# London Luton Airport Expansion

## **8.41 Surface Access Noise Modelling Additional Information**

Application Document Ref: TR020001/APP/8.41

<b>Deadline:</b>	Deadline 3
<b>Planning Inspectorate Scheme Reference:</b>	TR020001
<b>Document Reference:</b>	TR020001/APP/8.41
<b>Author:</b>	Luton Rising

Drawing Title Figure 1  
 Change in 2043 Do-Something - Do-Minimum Daytime LAeq,16h Surface Access Noise Contours

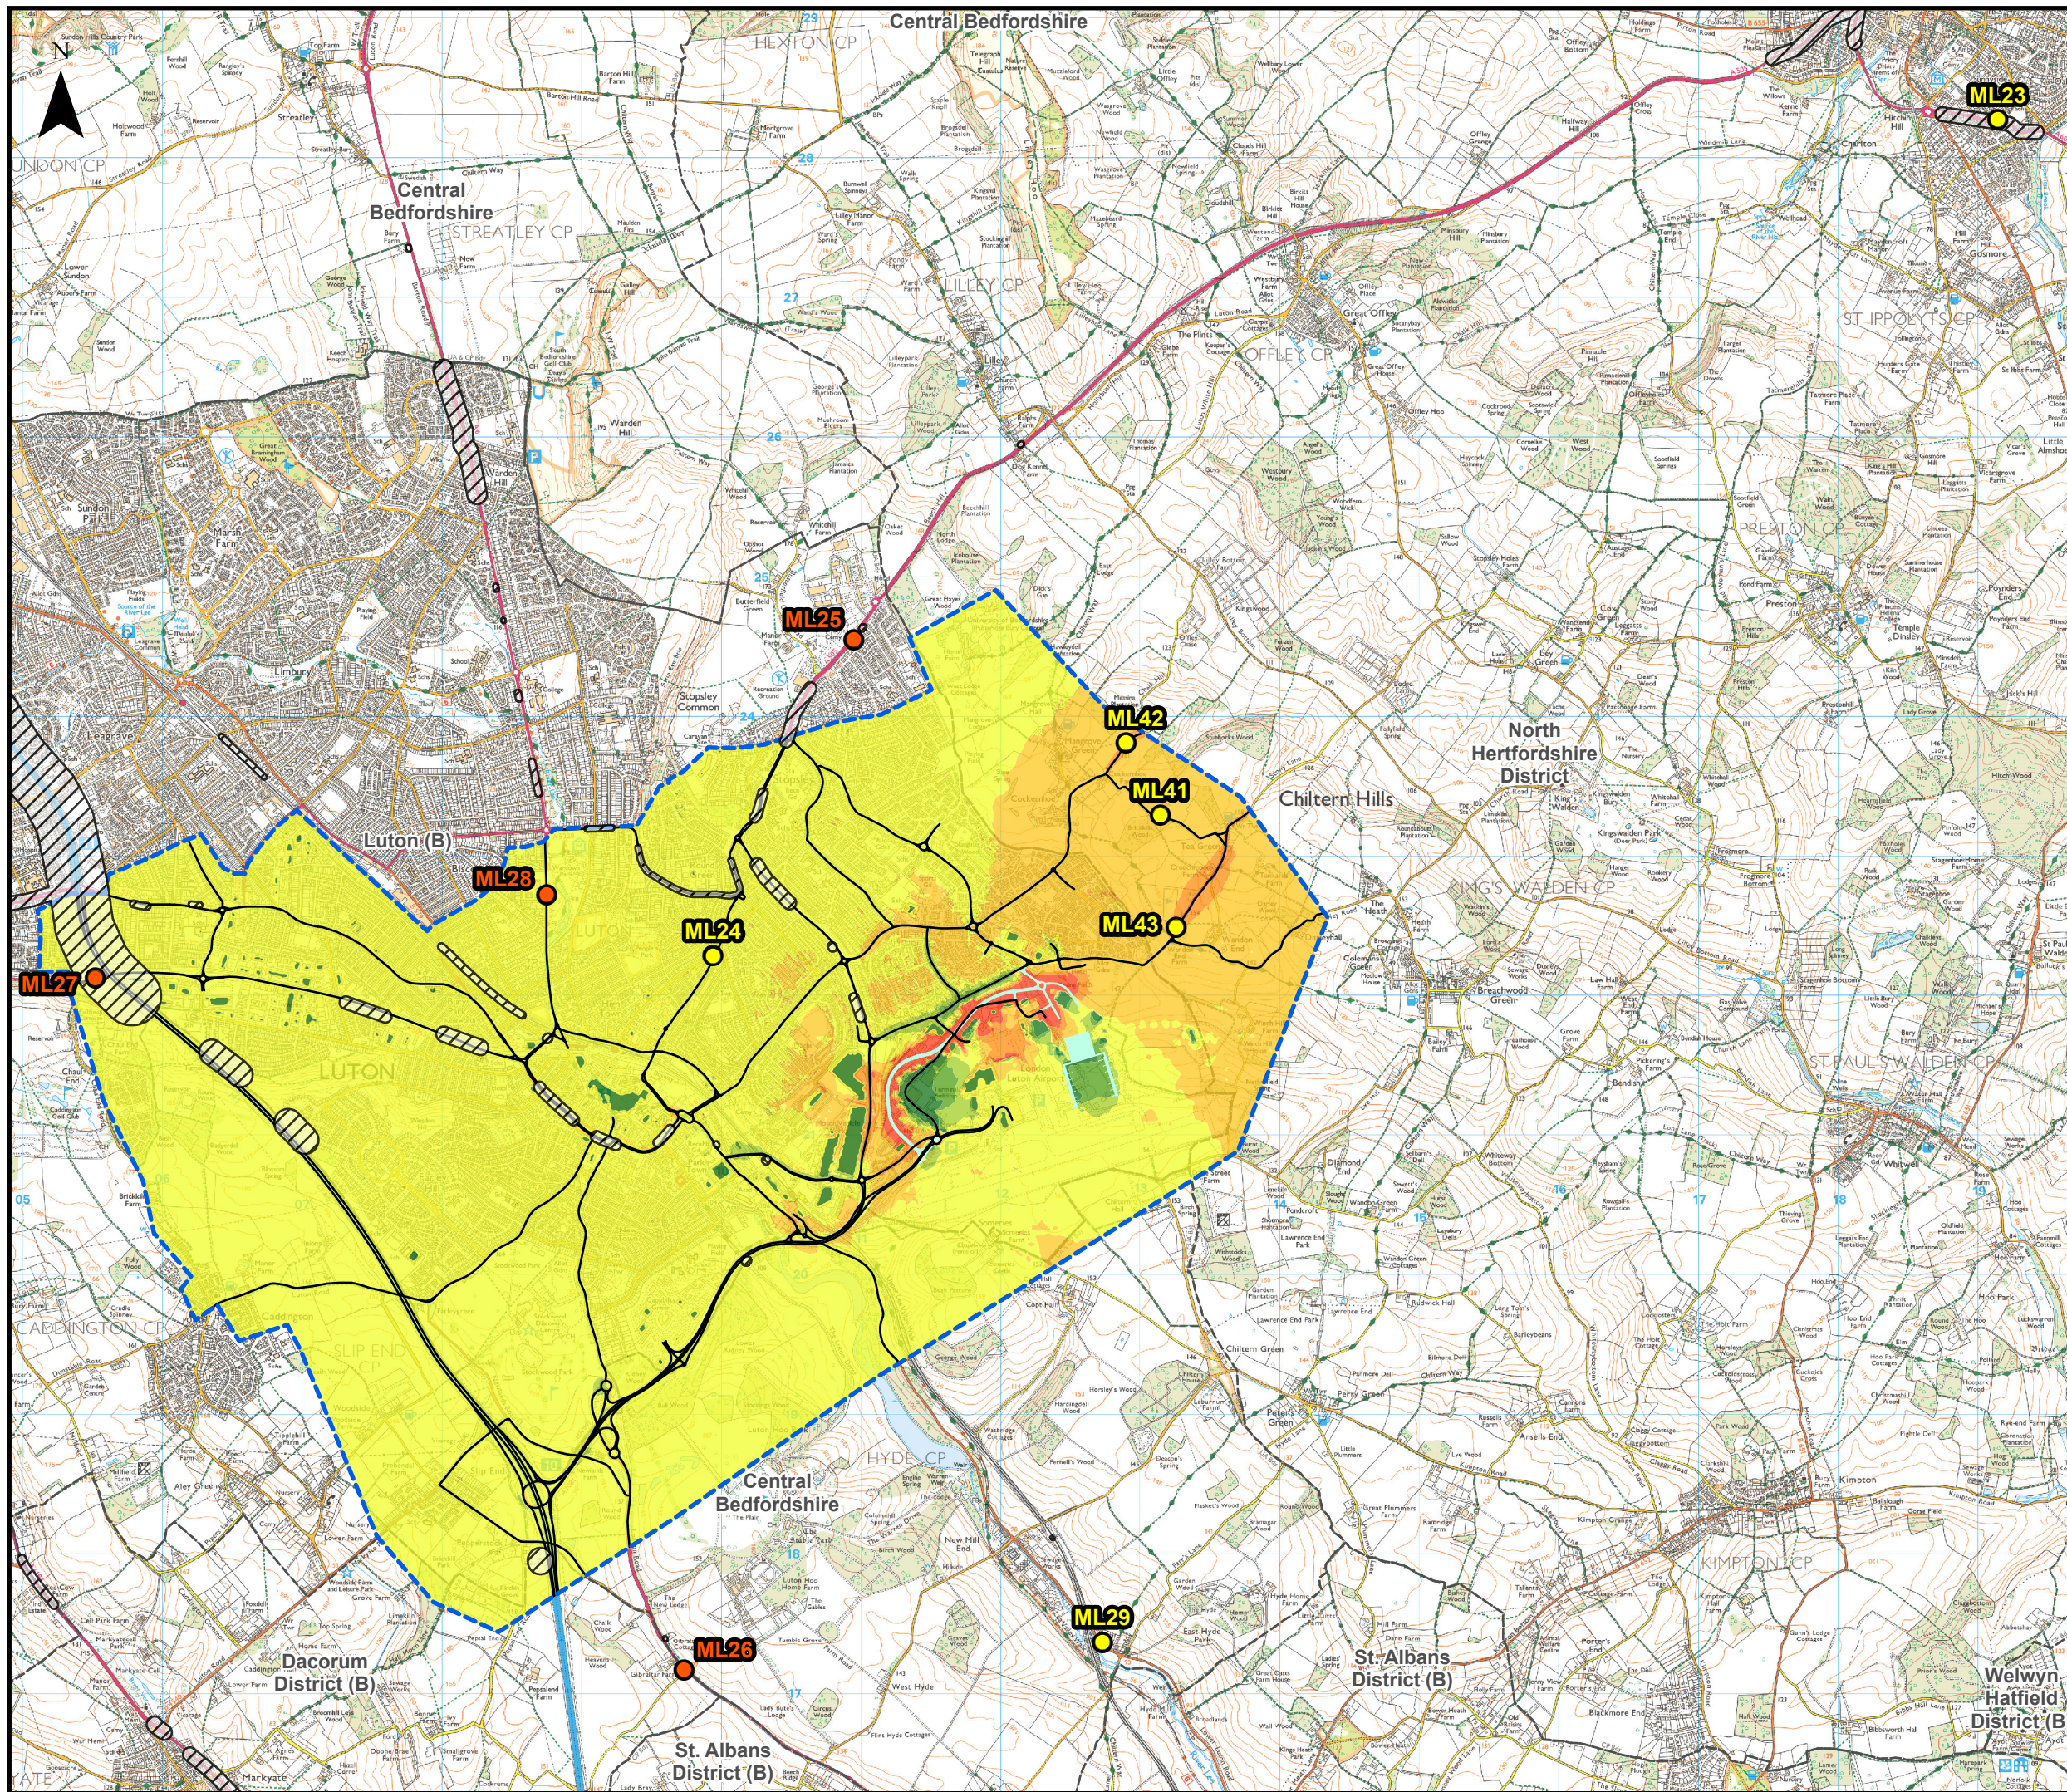
- 3.1.3 The HAs have also queried the validation of the surface access noise model, with references to instances where the measured and predicted values, with respect to the modelled baseline, differ by more than 3 dB. They recommend a clear explanation of these differences, and further justification for why the model can be relied upon.

- 4.2.4 It is noted by the HAs that at four of these 11 locations (ML25-28) the L<sub>Aeq,16h</sub> derived from the measured sound levels differs by more than 3 dB from the L<sub>Aeq,16h</sub> derived from the road traffic noise model.

- 4.2.10 Figure 1 and Figure 2 of this document show the monitoring locations overlaid on the surface access noise change contours for 2043. These figures show that the monitoring locations in question are either in areas expected to experience a negligible change in road traffic noise or outside of the surface access study area entirely<sup>2</sup>. Given that localised corrections to the model would be applicable to both the Do-Minimum and Do-Something scenarios, the only change would be to absolute levels reported in the vicinity of these locations. And as explained in Section 4.1 this would not alter the conclusions of the assessment.

- 4.2.5 However, it should be noted that it is not standard practice to calibrate or adjust a road traffic noise model, representing annual average conditions, using data from short term three-hour measurements which are subject to particular traffic conditions on the day of measurement which may be atypical as well as requiring conversion to 16-hour levels based on assumed diurnal traffic patterns. Measured sound data will also record all sound sources at each location whereas the road traffic noise model only calculates the contribution from motorised vehicles. This uncertainty in one three-hour measurement is illustrated by the variability in sound levels at the long-term monitoring location. As can be seen from the measured levels reported in Table 16.25 of **Chapter 16 of the ES [REP1-003]**, there is a seven-decibel range in levels at the long-term position across one week. Given this range it is possible that modelled levels at all locations would be within 3 dB of the range of levels measured over the long-term.

- 4.2.6 Paragraph 16.7.14 of **Chapter 16 of the ES [REP1-003]** explains that traffic counts taken during the measurements indicated higher levels of traffic at some of these locations during the three-hour measurement period, than would be expected from an annual average. In addition, it is likely that other localised factors such as the condition of the road surface and the speed of the traffic at the time of the survey led to the reported difference in levels. For example, the road surfaces at these monitoring locations are quite worn, leading to higher road traffic noise levels than expected from the model where a correction applicable to a new Hot Rolled Asphalt surface has been assumed (Ref 6), as reported in Section 9.3 of **Appendix 16.1 of the ES [AS-096]**. This assumption is standard practice for local authority roads, and it is not proportionate, or even feasible in some cases, to measure the precise acoustic performance of every road surface in the study area.

- 4.2.7 For these reasons, it is not best practice to make a universal adjustment to the CRTN model to match spot measurements. Confidence in the road traffic noise model comes from the long-term validation of the core calculation methodology from thousands of measurements at the time of creation (Ref 7), decades of road traffic scheme assessments for which CRTN has been considered fit for purpose and a robust quality assurance procedure for checking the model input data. In particular, the monitoring locations in question represent locations close to busy yet free-flowing roads and it is precisely this situation for which CRTN was specifically designed to be most accurate.

- 5.1.1 Following submission of this paper at Deadline 2, further technical discussions were held between the Applicant and the HAs and their noise consultant. In these sessions, the four monitoring locations that had previously been queried due to discrepancies of greater than 3 dB (ML25-28) were discussed in detail, including a review of the locations using Google Streetview.

- 5.1.2 This exercise identified justifiable reasons for the discrepancies that are specific to the measurement locations and spot check exercise, including:

- a. planned survey locations were used in the spot-check exercise, however for these four locations the actual survey location was slightly updated on the day to due to survey practicalities;

- b. each of the four locations were 3-hour short term measurements which cannot be directly compared to long term annual average weekday model outputs (DMRB itself cautions the comparison of short-term measurements to long-term predictions at paragraph 4.2); and

- c. there were localised road surfacing conditions for each of the four locations that would influence the noise levels.
- 5.1.3 Following this exercise, the spot check exercise was repeated with the corrected actual survey locations, and details of the road surfacing conditions were provided to the HAs in writing, as per **Table 5.1**. As a result, it was agreed between the Applicant and the HA's noise consultant that the discrepancies are due to locations specific factors, and it was agreed that the surface access noise model is appropriate. This will be recorded in the next update of the Statements of Common Ground.

- 5.1.4 Figure 1 and Figure 2 within this document have been updated with the corrected survey locations (this has only affected ML25-28).
